**Cumberland County Subdivision and Land Development Review Report**

Municipality:	<u>Silver Spring</u>	Surveyor/ Engineer:	<u>Integrated Development Partners</u>	Owner/ Developer:	<u>Shreekaya LLC</u>
Plat Title:	<u>Tulips at 38 Woods Drive</u>				
Plat Status:	<u>Preliminary/Final</u>	Plat Type:	<u>Subdivision &amp; Land Development</u>		
# of New Lots:	<u>20</u>	# of New Dwelling Units:	<u>20</u>	New Acreage Subdivided/Developed:	<u>14.66</u>
				Total Tract Acreage:	<u>14.66</u>
Zoning District:	<u>R-1</u>	Proposed Land Use:	<u>Residential</u>		
Date Received:	<u>4/9/2020</u>	County Review:	<u>4/20/2020</u>	Reviewed by:	<u>SH</u>
				Checked by:	<u></u>

10 of 27

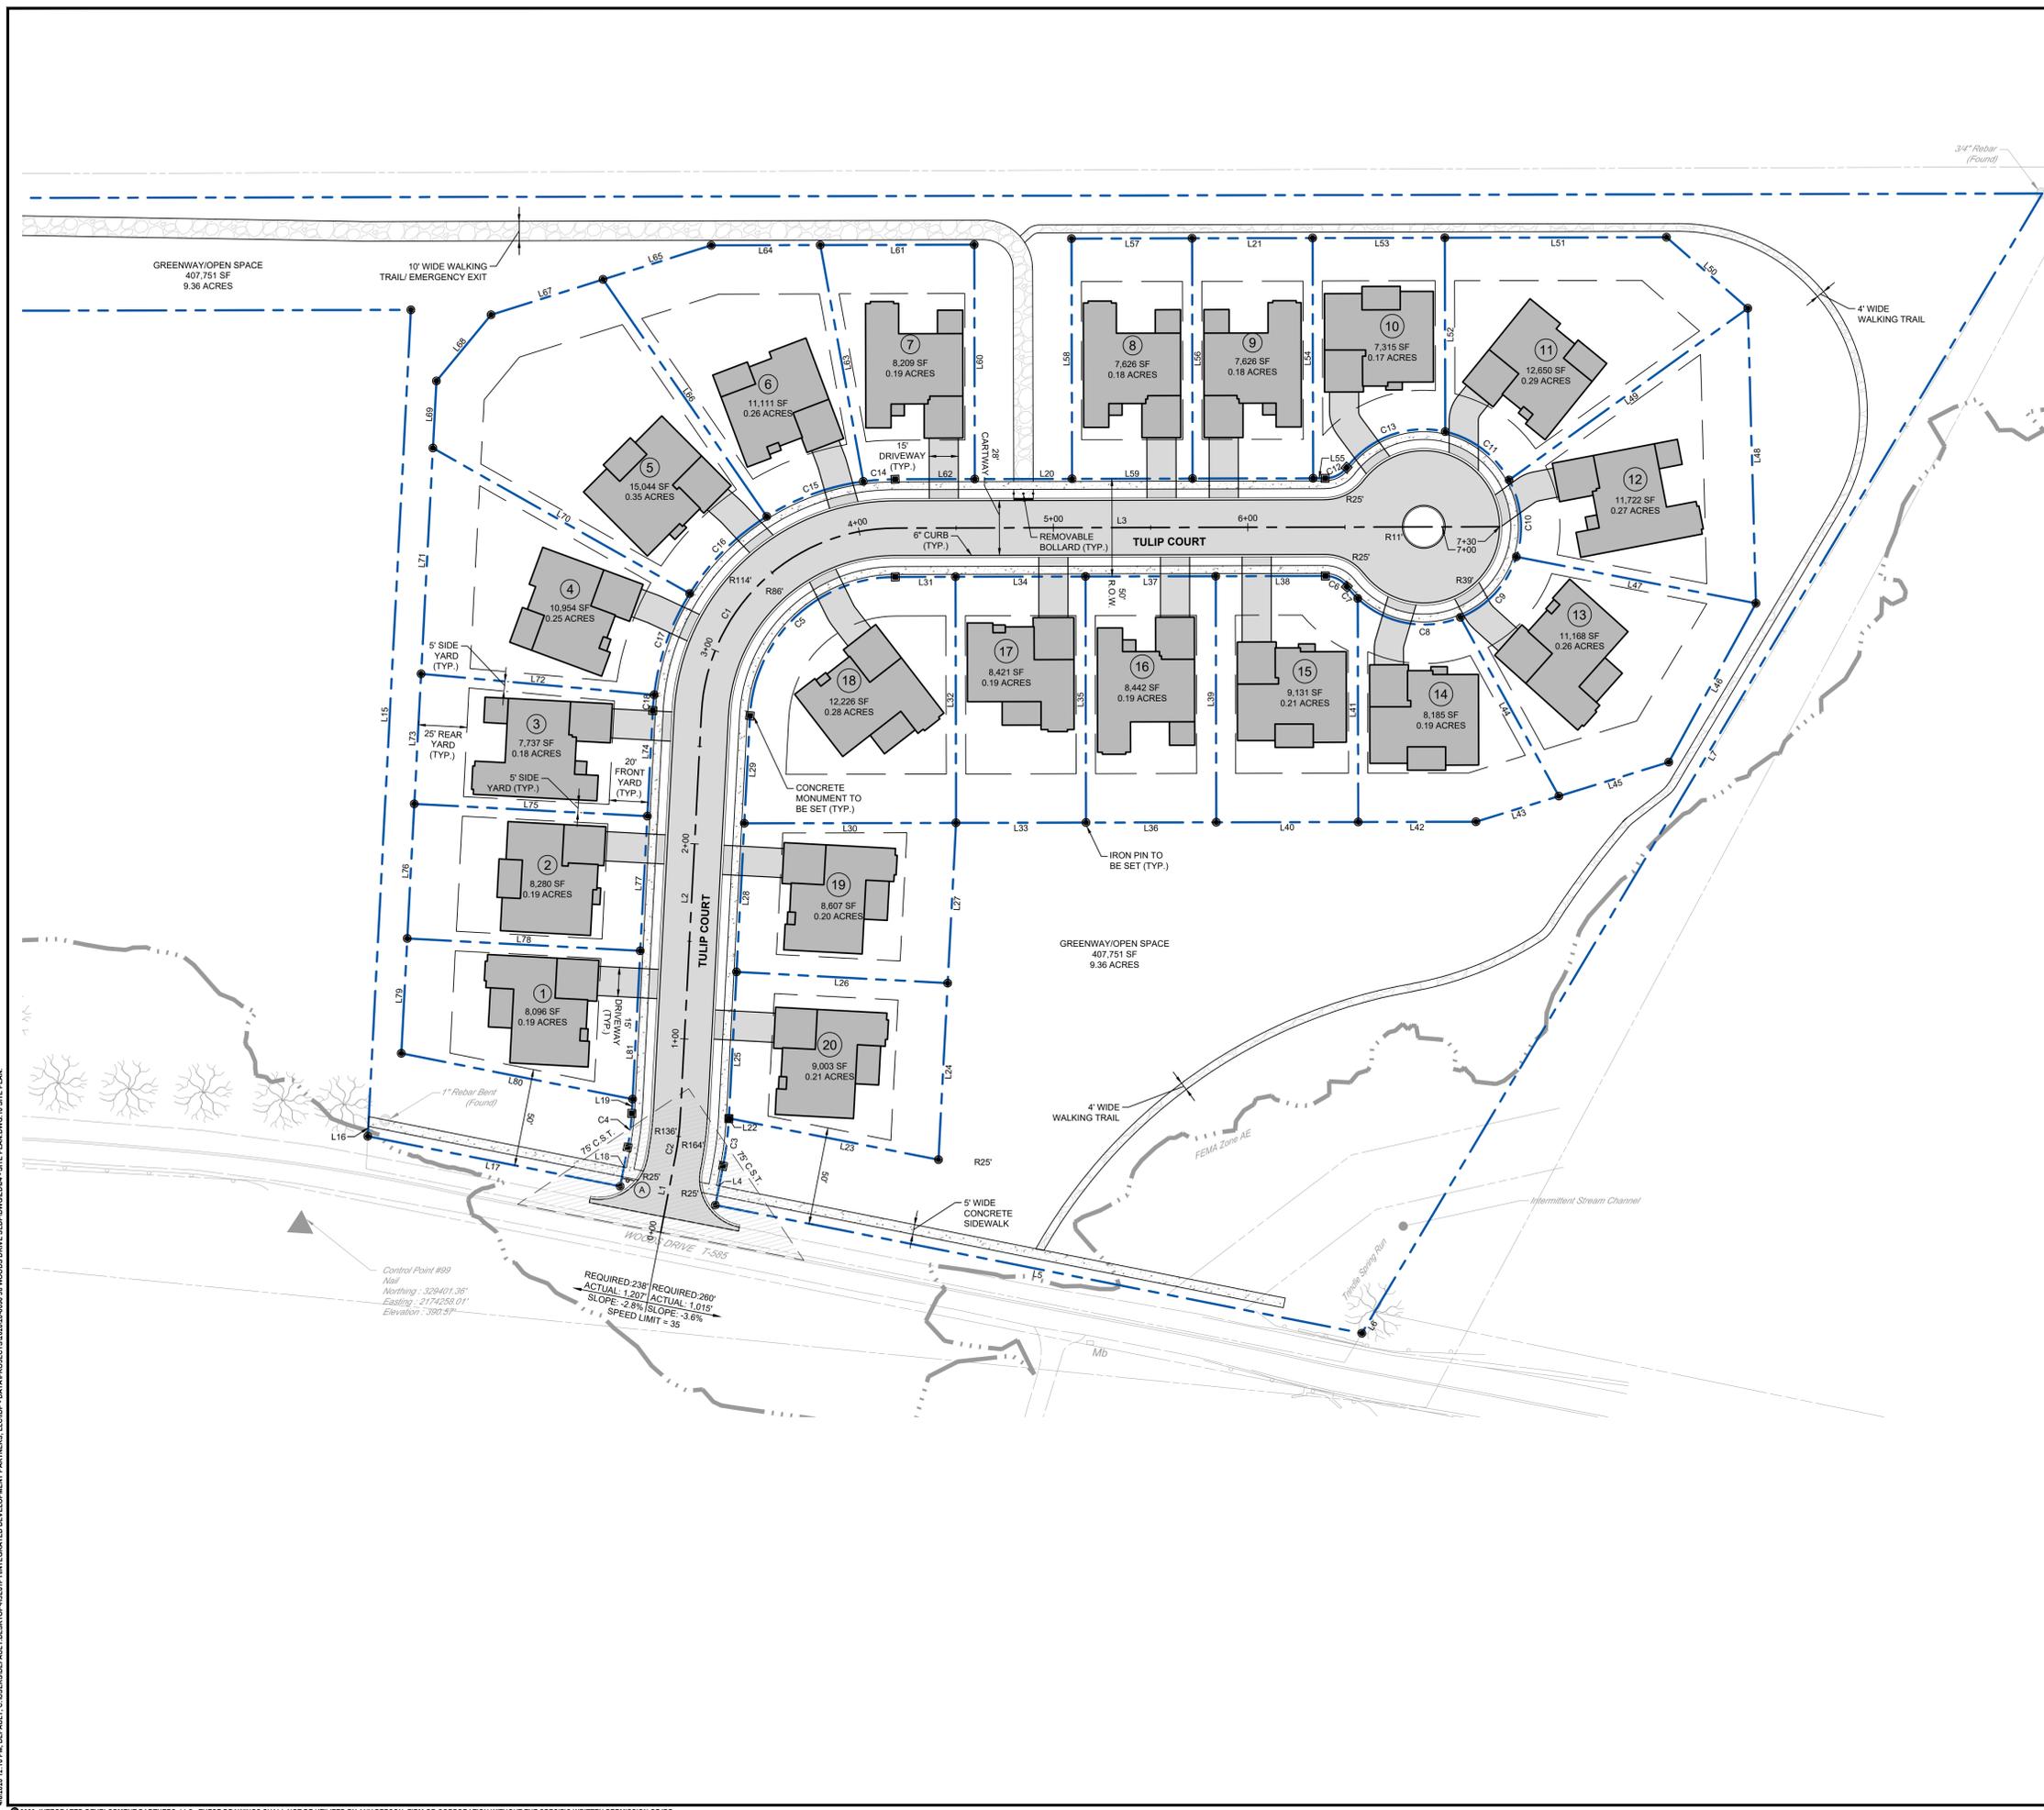
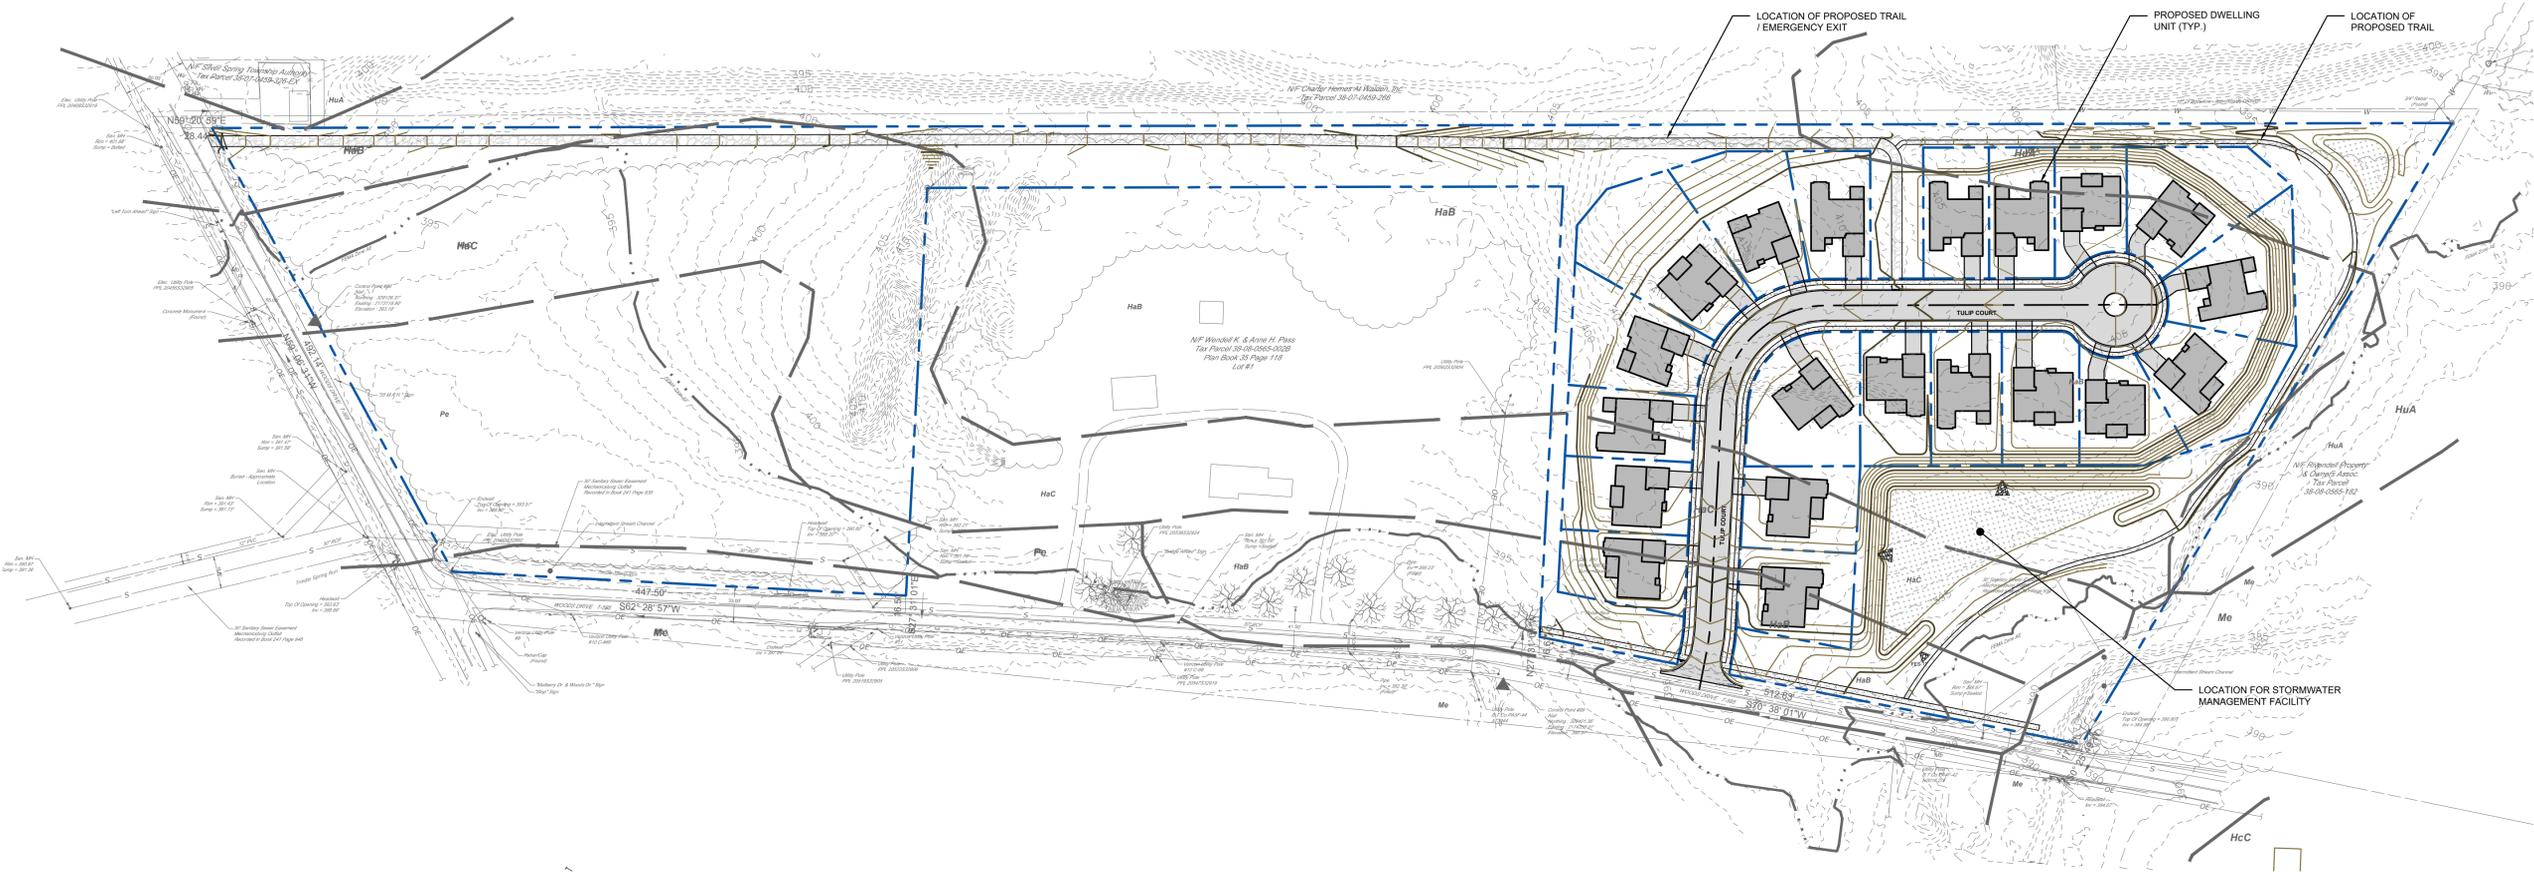
3. Sheet 10 indicates that a 75' Clear Sight Triangle has been provided. A 100' Clear sight triangle should be shown (SLDO 602.12.6).
4. A Clear Sight triangle should be provided at each driveway on the Landscape Plan (SLDO 602.17.4).
